Tech Bulletin

Series RT Spool Improvement

Form # TB0049 Rev: 4/2020

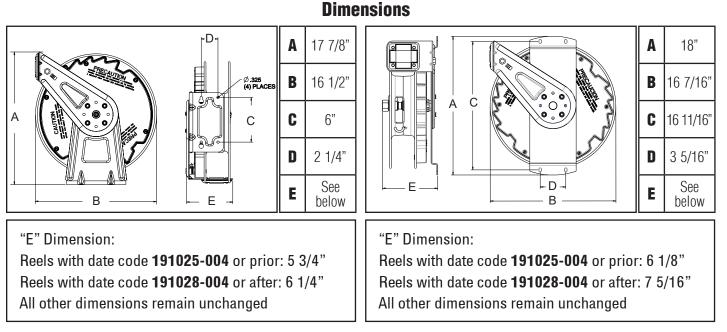
In the spirit of continuous improvement, the need to upgrade the Series RT spool material was identified. The spool is now produced from a new engineered plastic proven to be highly durable in environments such as industrial usage and weather cycles. Due to the improvement, the physical reel width slightly increased for the following reel models (including side mount):

If the date code is not available, for easy identification reference the spring case fasteners:

New RT spool Fasteners

Previous RT spool No Fasteners
